A D D E N D U M #2

Project	Nelson H.S. Renovations	**Project No.**	2323
Location	4181 New Street, Burlington, Ontario	**Date of Issue**	2024 05 30
Owner	The Halton District School Board	**File**	2323/7.1.3

This Addendum forms part of the Contract Documents and amends the original Drawings and Specifications, dated 2024 05 13, as noted below.

1 M3.11 PARTIAL ROOF PLAN
Scale: 1:100

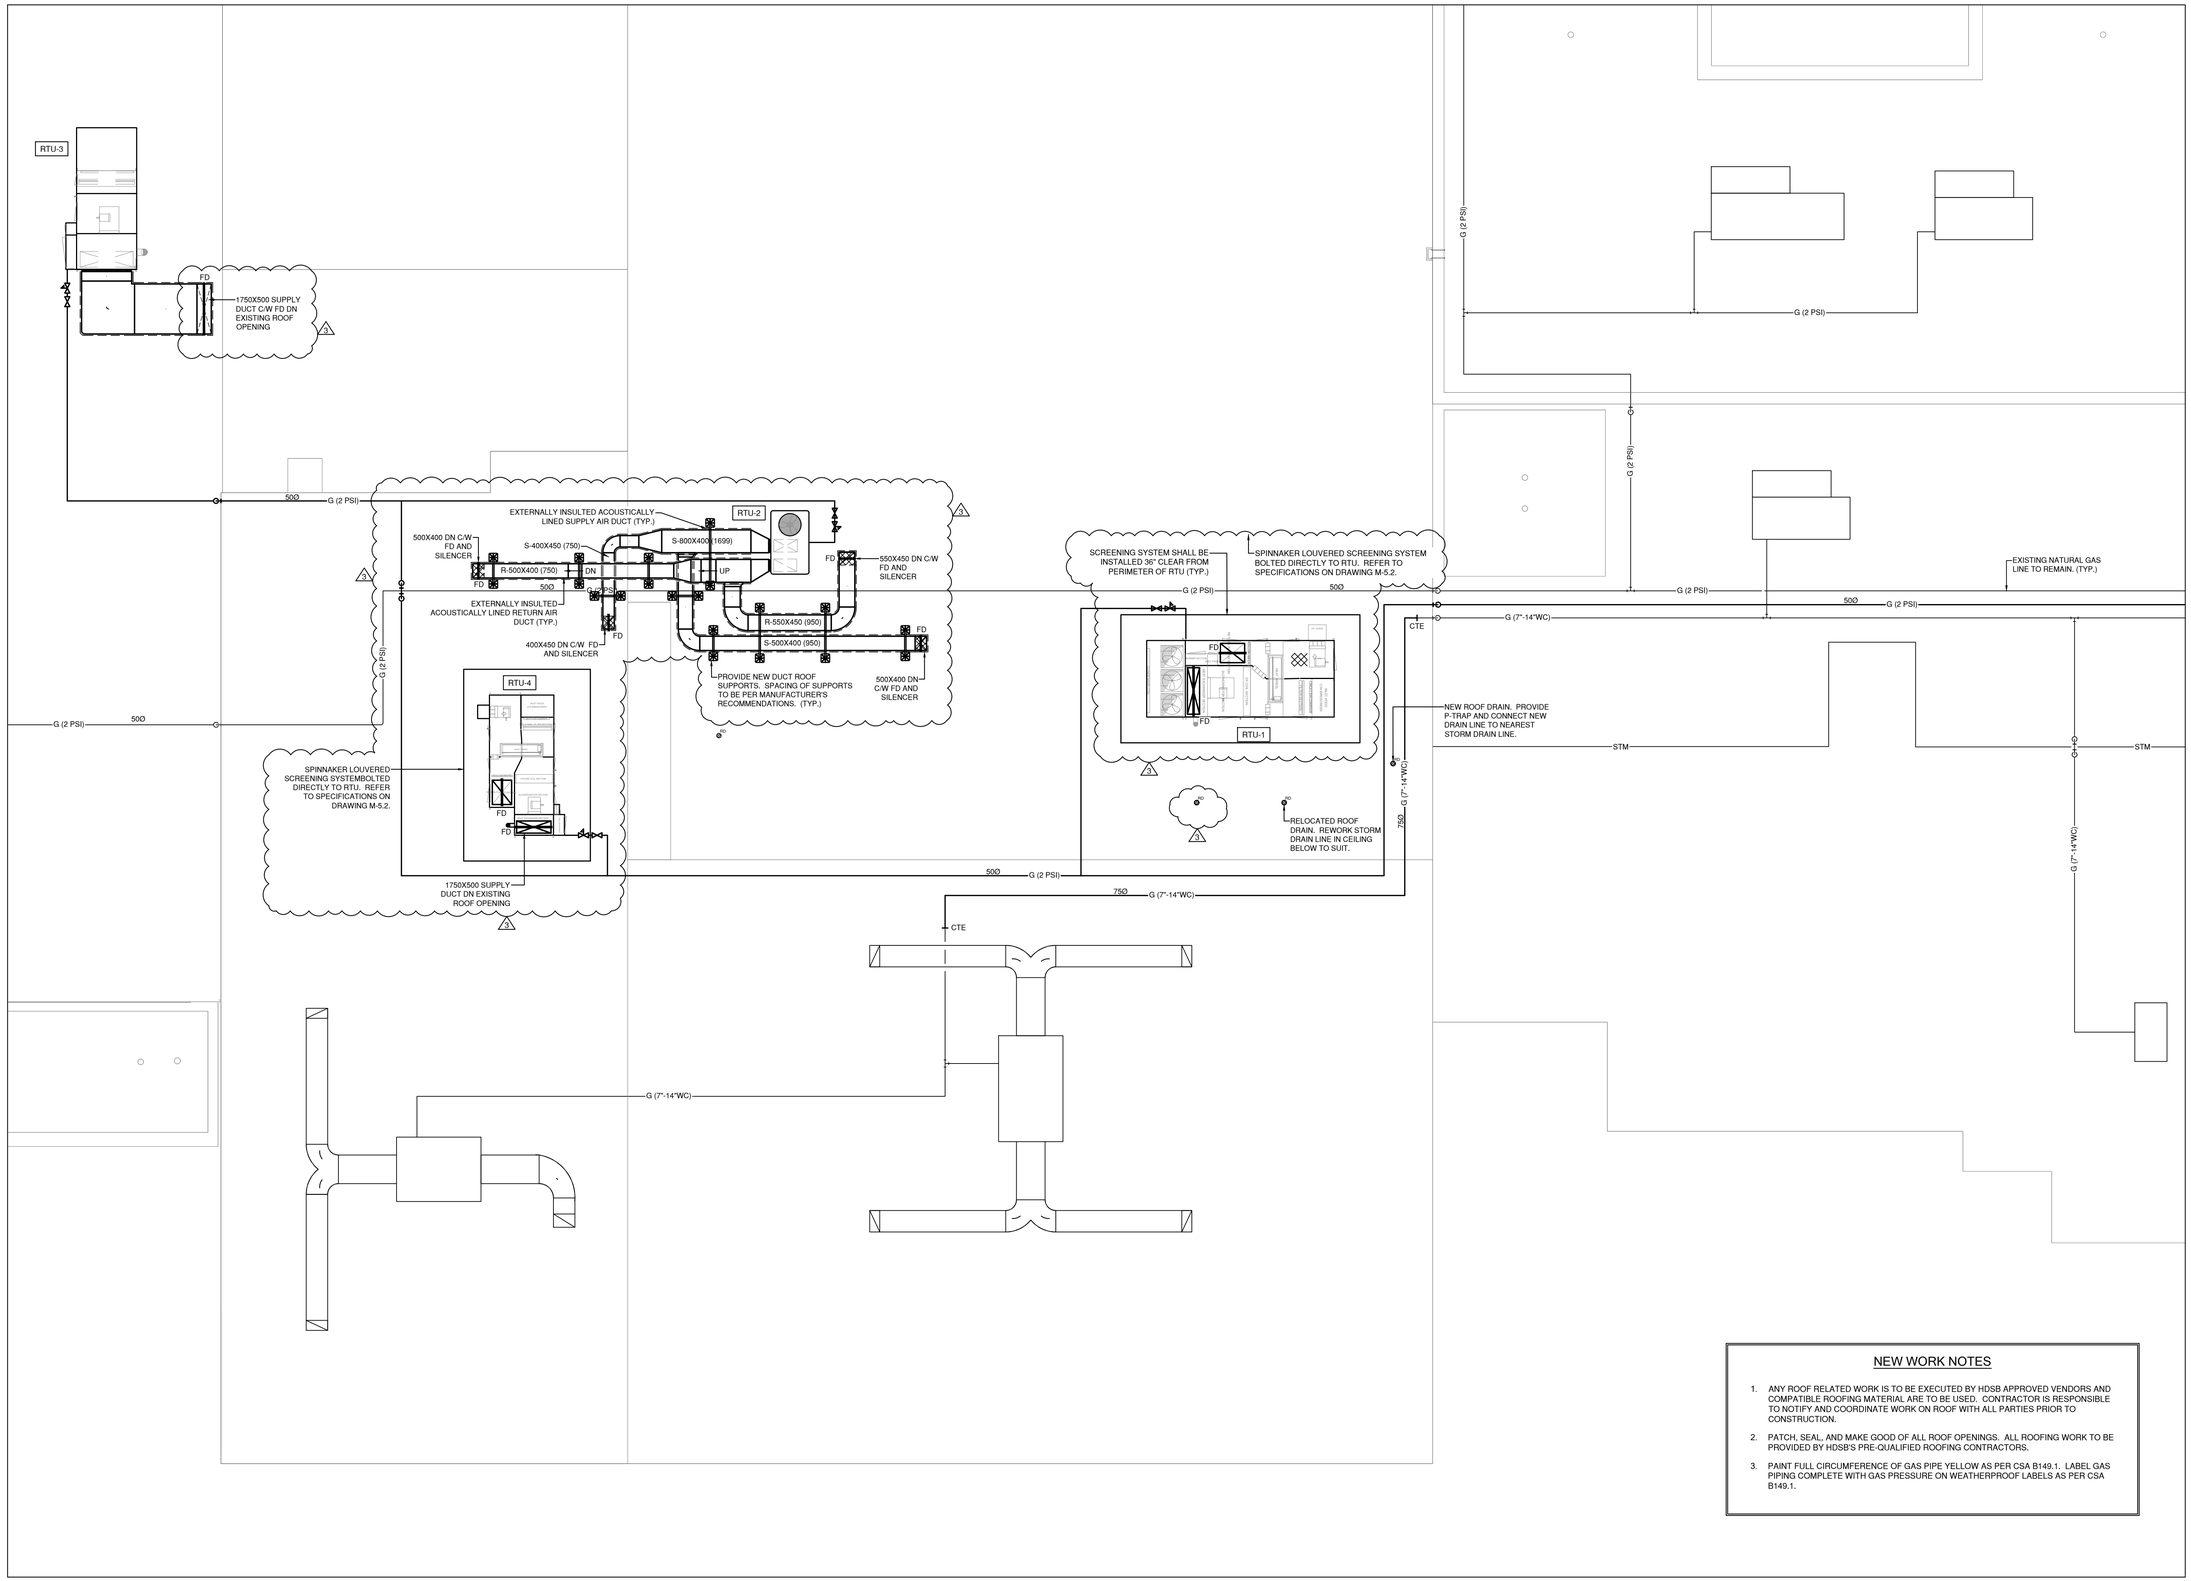
.1 Refer to detail 1, provide louvred screening system for RTU-1 and RTU-4 as indicated.
.2 Refer to detail 1, revise supply and return air duct connections of RTU-2 (Music) to side discharges and run ducts on roof as indicated. Provide roof duct support as required.
.3 Refer to detail 1, add one (1) new roof drain as indicated.
.4 Refer to detail 1, revise quantity, dimensions, and locations of supply and return silencers of RTU-2 as indicated.
.5 Refer to detail 1, shift new gas line as indicated.
.6 Refer to detail 1, provide fire dampers in supply and return air duct drops penetrating the roof assemblies as indicated.

Scale:	1:250	Date:	MAY 2024
Drawn by:	FH	Checked by:	TM
Job No.	23178	Drawing No.	E100

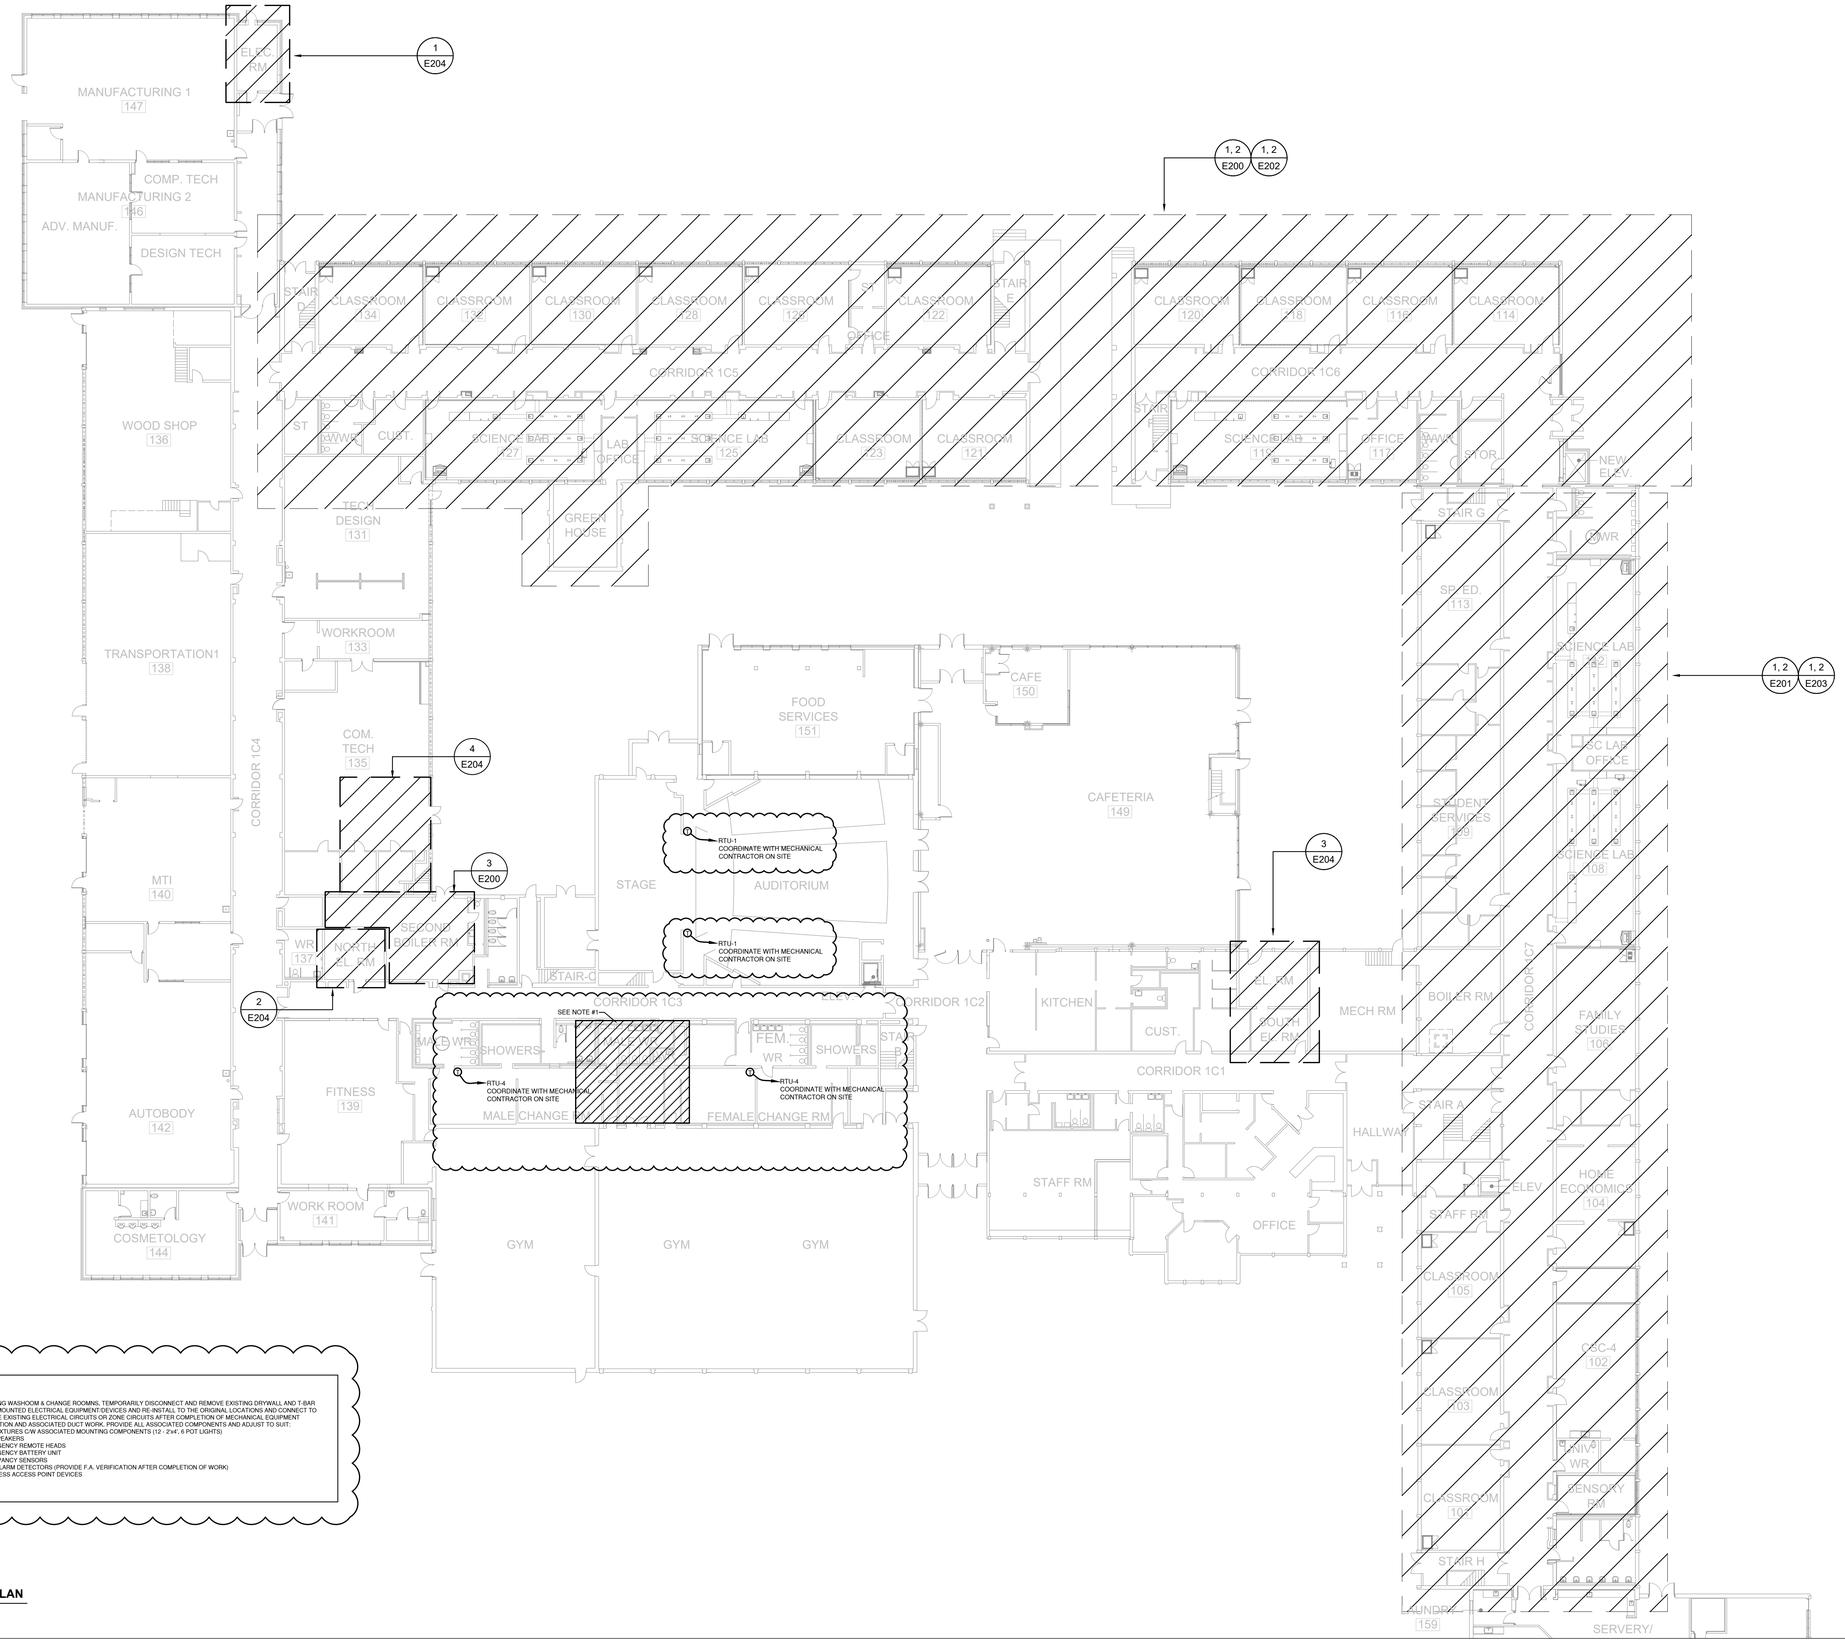
.1 Refer to Drawing E100 and include the changes indicated. Rough-in for Temperature sensors have been added.
